Errata disclaimer: This Errata applies to SLG46140 revision LS.

ISSUE 1: Long Ring OSC Settling Time

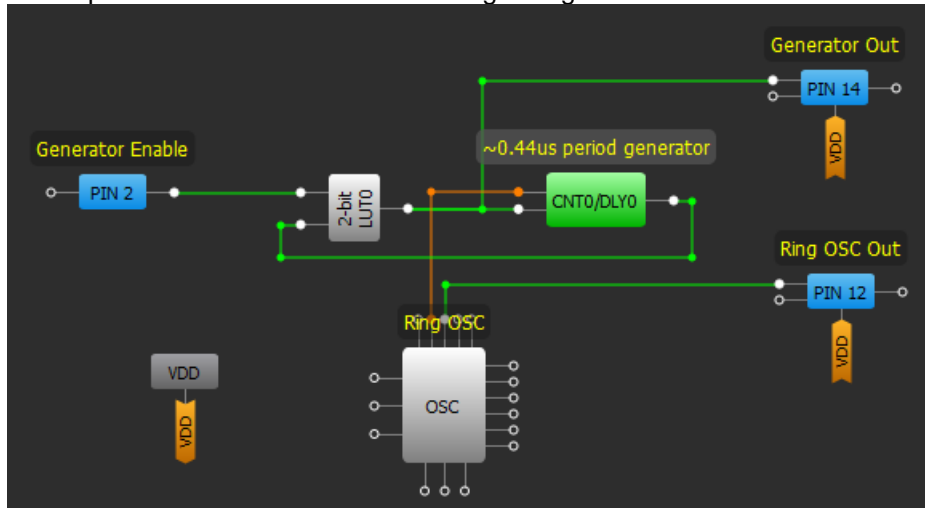
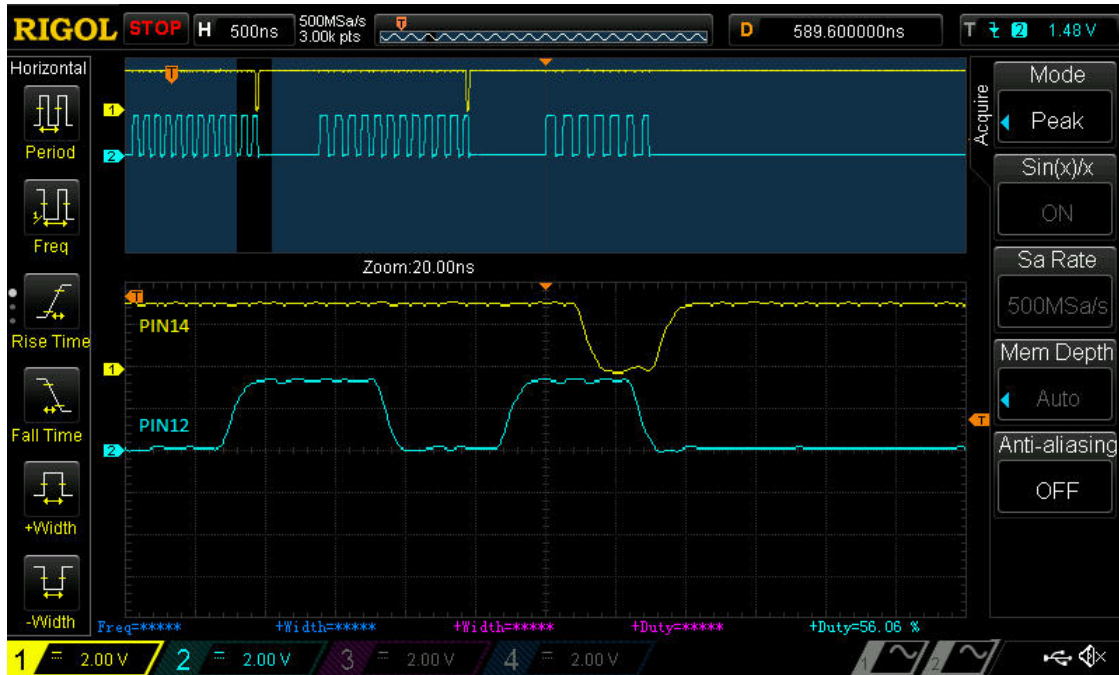
The Ring OSC has a longer settling time when configured as Auto Power On in the designs that have very short Ring OSC disable time. An example of such issue is in the following configuration:

The configuration shown above generates a periodical signal with a frequency defined by the Delay cell and started by a high signal on PIN2. The issue becomes apparent in a longer settling time when the scheme generates short pulses (Delay is configured as a rising edge delay only). See waveform below.

Such behavior will lead to substantial error in period calculations if the delay time is relatively small.

- Set Ring OSC power mode to “Force Power On”
- Set Turn on by register option in BG (Band Gap) block as “Enable”

Channel 1 – 2-bit LUT0 output; Channel 2 – Ring OSC output

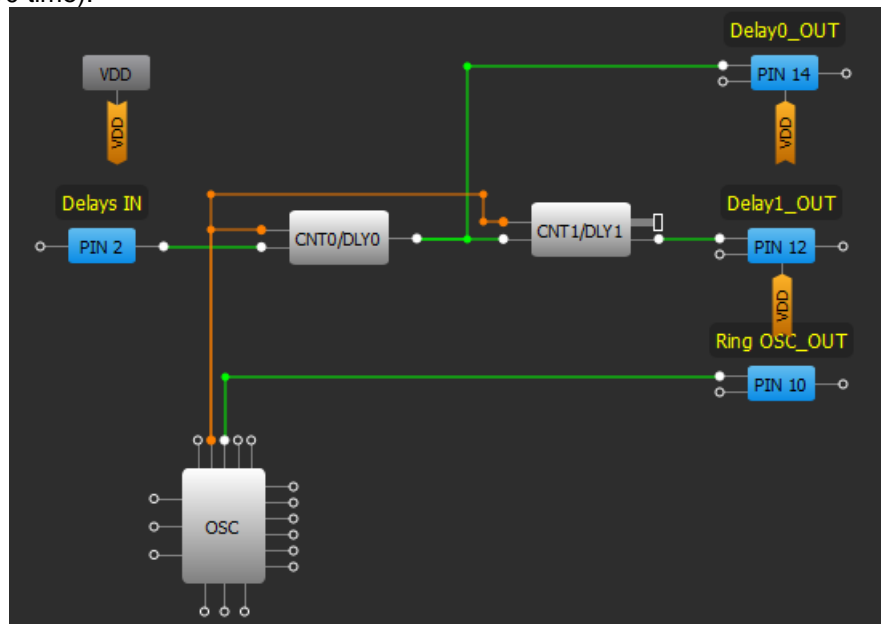
A similar situation occur while using two connected delays (all edge detect types except for a pair “Rising edge DLY – Falling edge DLY”).

In the following example, Delay0 and Delay1 are configured in the same way. However, Delay0 time is 11.4us instead of expected 0.4us (Delay0 time).
